# UNITED STATES PATENT AND TRADEMARK OFFICE

10/002,985

<b>Office Action Summary</b>	Application No. 10/002,985	Applicant(s) ROUSE ET AL.	
	Examiner William H. Rodriguez	Art Unit 3746

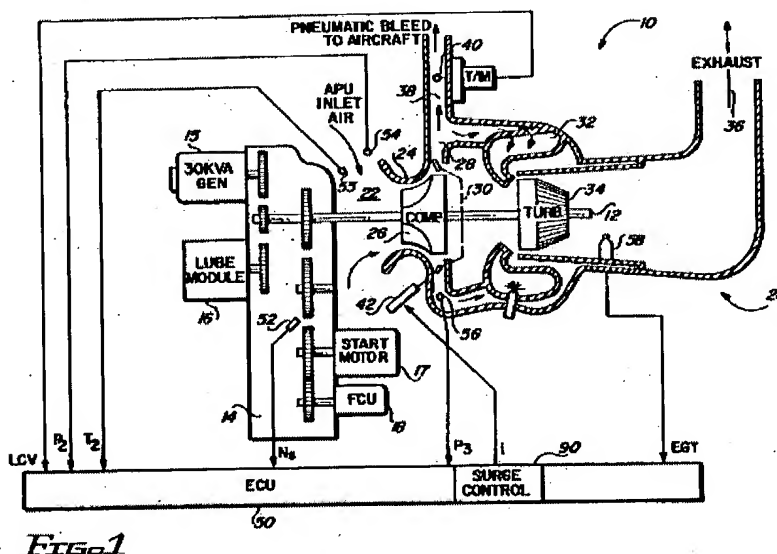
With respect to claim 15, **Evenson et al.** teach a system, comprising: a turbine 34 driven by hot gas; a combustor 32 for combusting fuel and compressed air to generate the hot gas; an air compressor 24 rotationally coupled to the turbine 34 to provide the compressed air; a bleed valve 40 connected to the compressor discharge to vent a selectable portion of the compressed air while the system speed is between a predetermined lower surge line and a predetermined upper surge line to prevent the compressor from stalling; and a controller 50 for controlling

system speed  $N_s$  to provide a required amount of power, controlling the bleed valve 40 to maintain a required airflow through the turbine inlet, and controlling the turbine exit temperature EGT to a temperature exhaust value derived as a function of system speed  $N_s$  and ambient conditions  $P_2$ ,  $T_2$ . See particularly **Figure 1**, column 3 line 20-22, and column 3 lines 39-54 of Evenson.

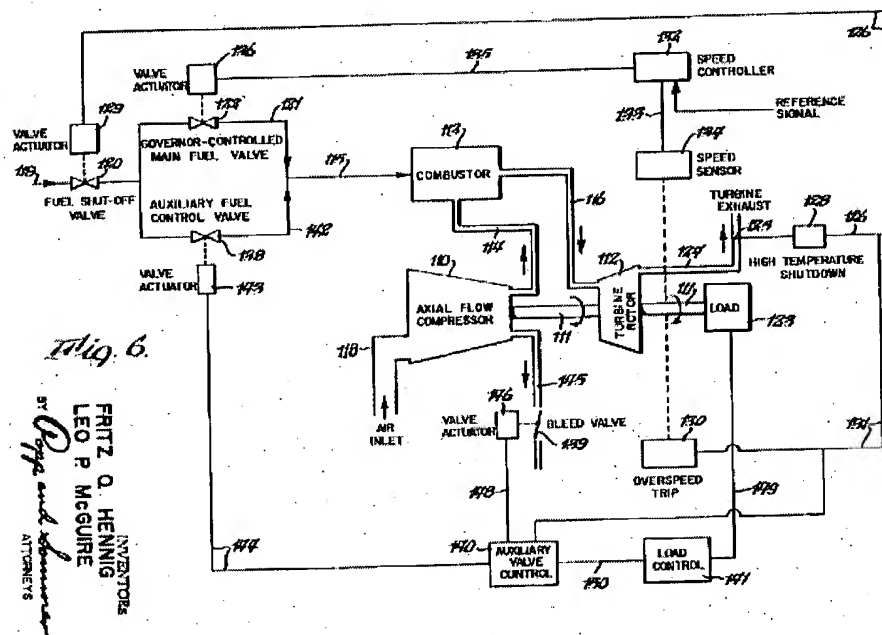
With respect to claim 15, **Henning et al.** teach a system, comprising: a turbine 112 driven by hot gas; a combustor 113 for combusting fuel and compressed air to generate the hot gas; an air compressor 110 rotationally coupled to the turbine 112 to provide the compressed air; a bleed valve 139 connected to the compressor discharge to vent a selectable portion of the compressed air; and a controller 140, 132 for controlling system speed to provide a required amount of

power, controlling the bleed valve 139 to maintain a required airflow through the turbine inlet, and controlling the turbine exit temperature TET to a temperature exhaust value derived as a function of system speed. **Henning** does not mention that the bleed-off of air is done to prevent or eliminate compressor surge or that the temperature exhaust value is derived as a function of ambient conditions. However, it is well known in the art that bleeding-off air from the compressor prevents surge from happening so indirectly Henning's bleed valve 139 prevents the compressor from stalling. Further, **Anand et al.** teach that low ambient conditions lead to compressor surge. Thus, although **Henning** does not mention controlling ambient conditions to prevent a compressor surge, ~~Therefore~~, it would have been obvious to one of ordinary skill in the art at the time the invention was made to have included a controller that monitors ambient conditions since these could lead to a surge compressor. See particularly **Figure 6** of Henning, and column 4 line 20-24 of Anand.
